From: [Whittaker, Roberta \(EXT\)](#)
To: [Jane Curley](#)
Cc: [Planning \(SMDC\)](#)
Subject: DOC/2024/0020 - Fole Dairy - LLFA Response
Date: 15 May 2024 12:06:06
Attachments: [image001.png](#)
[image002.png](#)

Thank you for consulting us on this DCON application – DOC/2024/0020 – Fole Dairy.

Staffordshire County Council Flood Risk Management Position

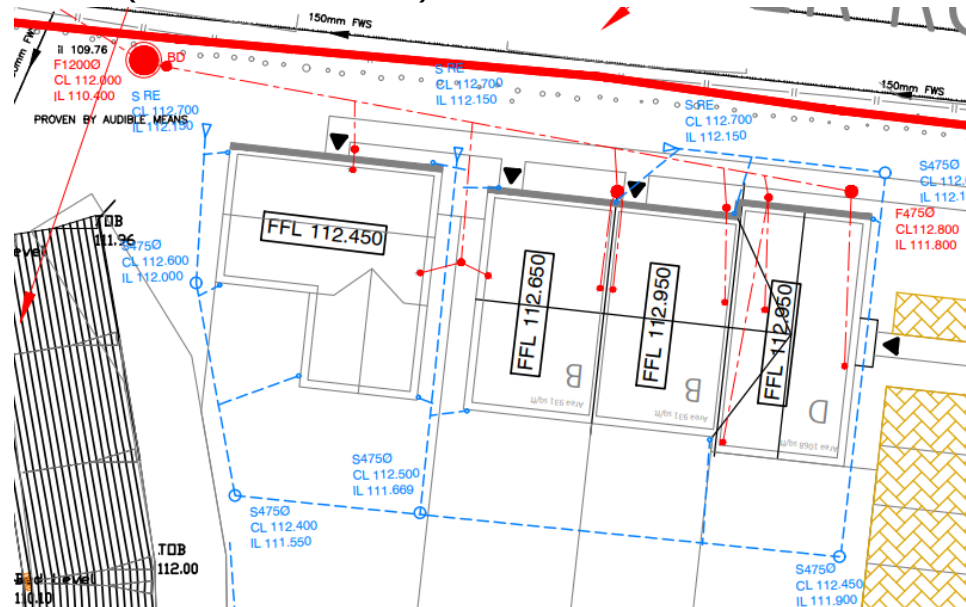
- Do we have an IA plan to check the area of the PP against the modelling?
- For all sites, why have some private pipes been modelled but others not? – we need to see a full representation of the drainage network in the modelling.
- For all sites, Why have the pipes from the attenuation tanks into the network been modelled?
- How does the microdrainage relate to the levels obtained in the watercourse from the hydraulic modelling?
